17DEVPLAN1192

4001 South Brook Street

**Louisville Metro Board of Zoning Adjustment
Public Hearing**

**Ross Allen, Planner I
December 4, 2017**

WILDER PARK PROPERTIES - VENOSA ADDITION

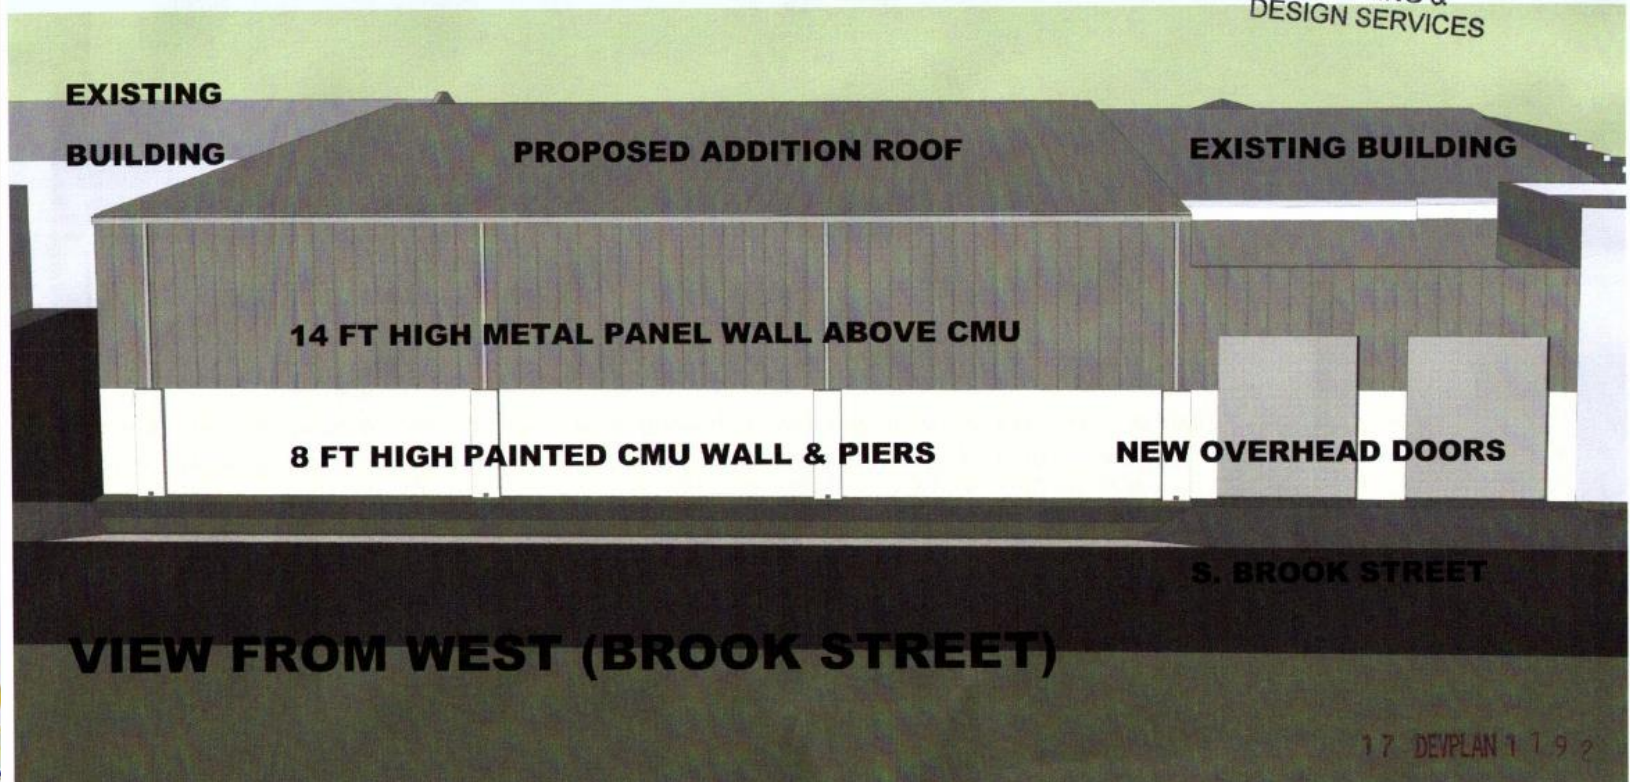
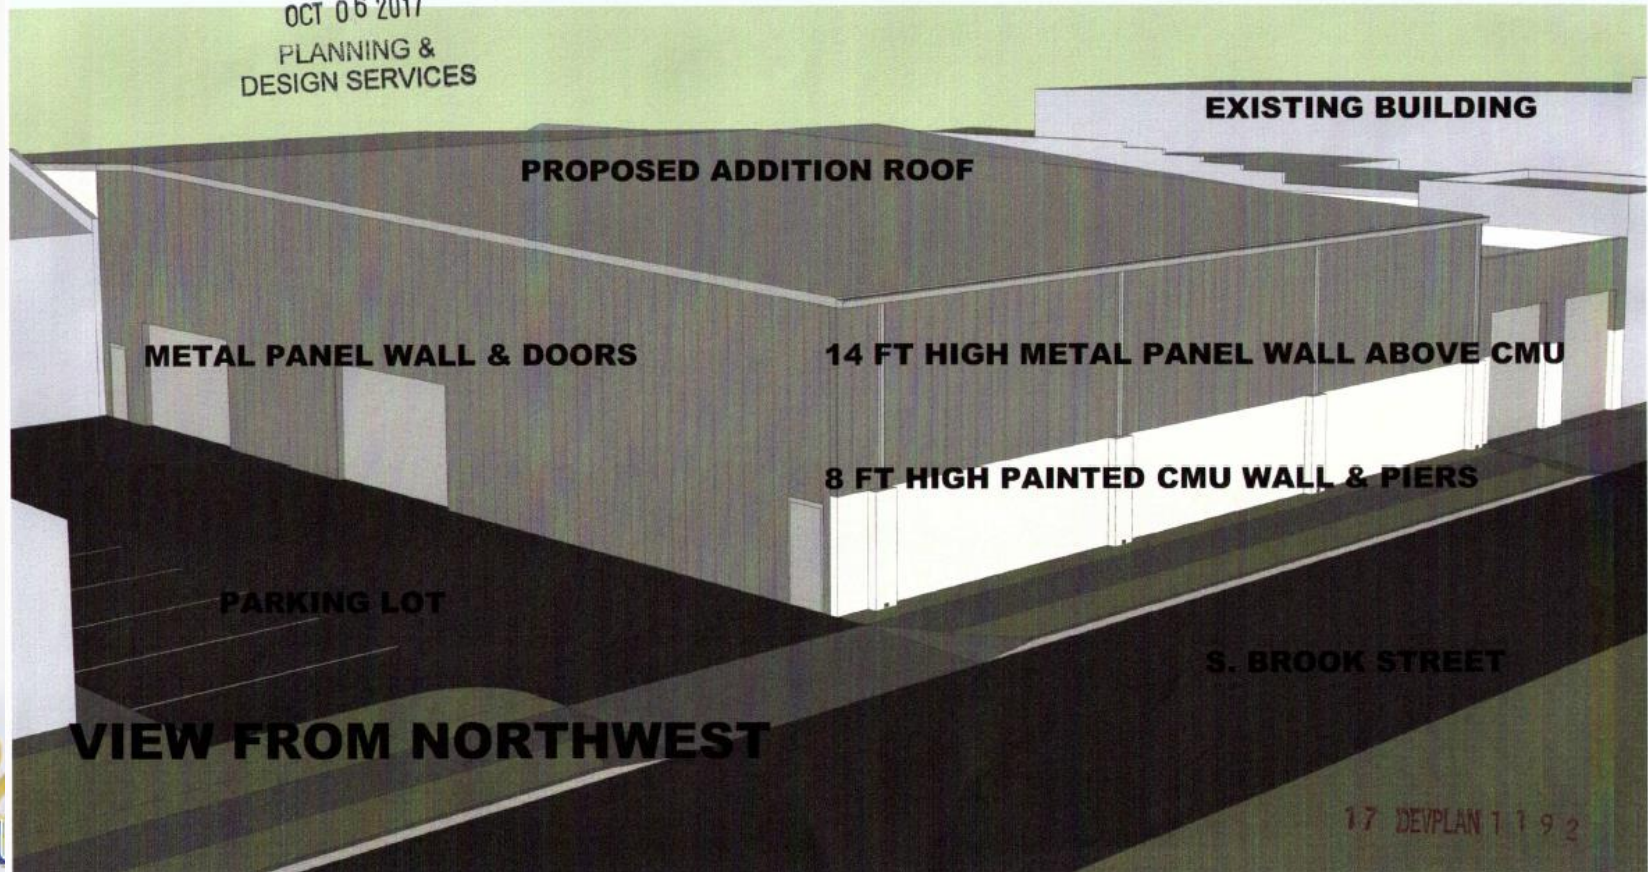
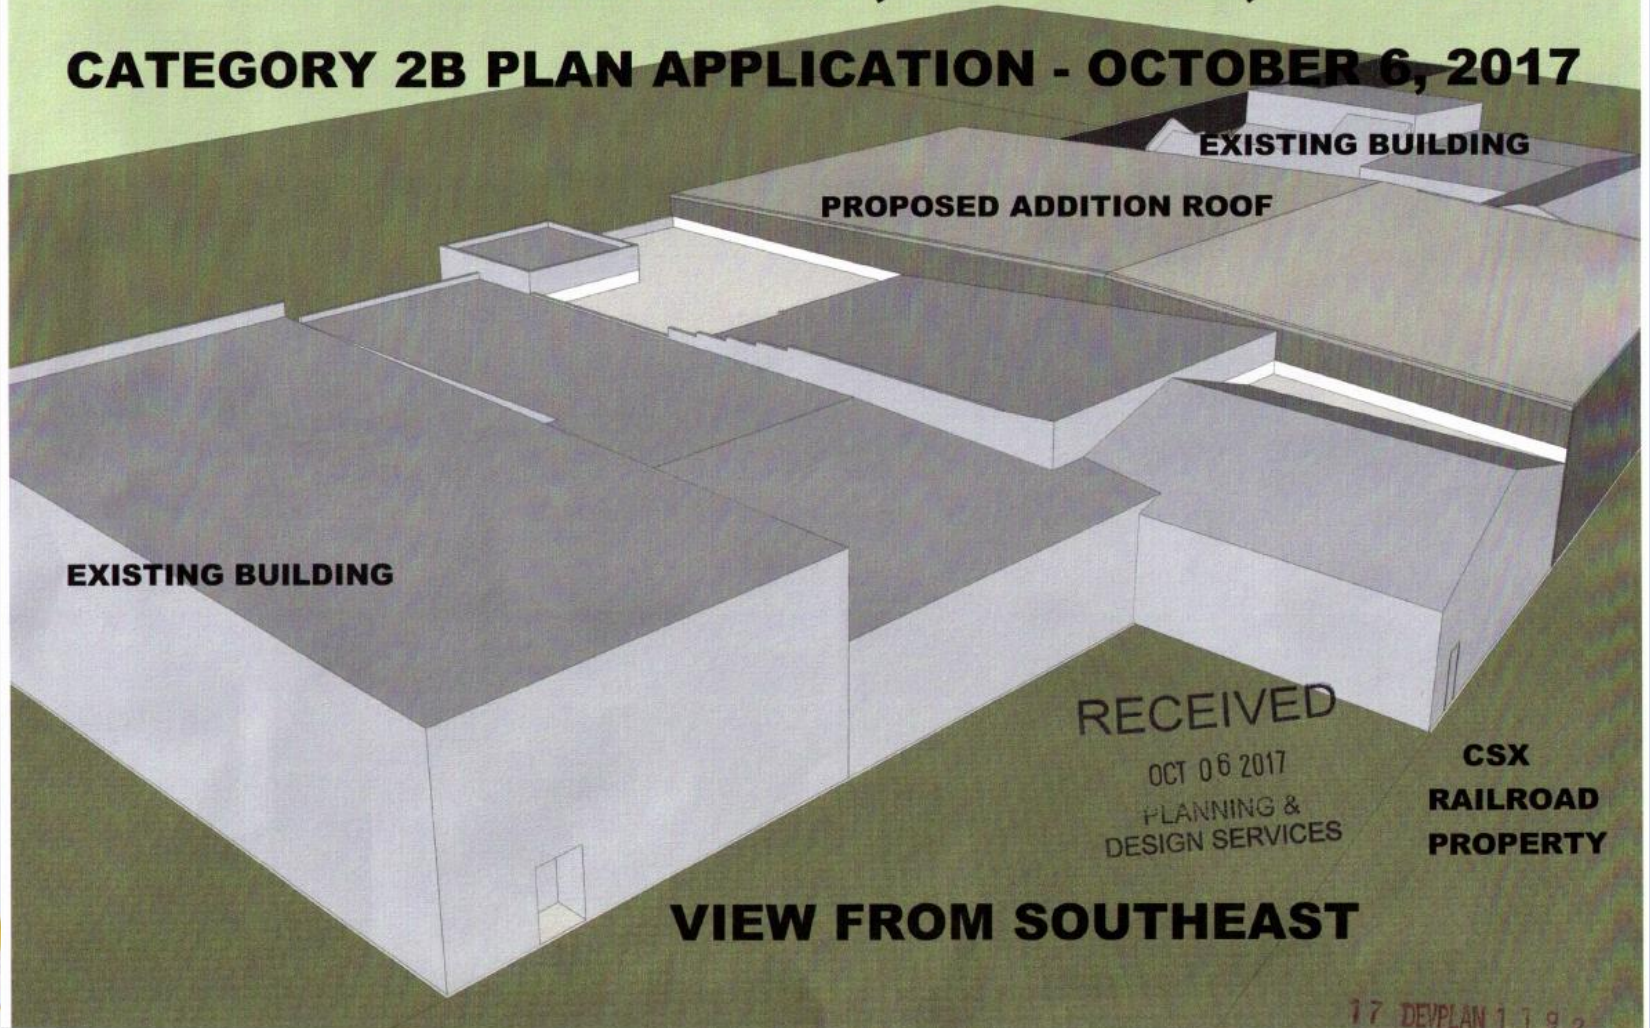
- The variance request appears to be adequately justified and meets the standard of review.
- Must determine if the proposal meets the standard of review for granting a variance as established in the Land Development Code (August 2017a) from section 5.3.4.D.3.a to allow a proposed 30 foot tall 12,794 sf. storage/warehouse to encroach 25 feet into the 25 foot front setback along South Brook Street.
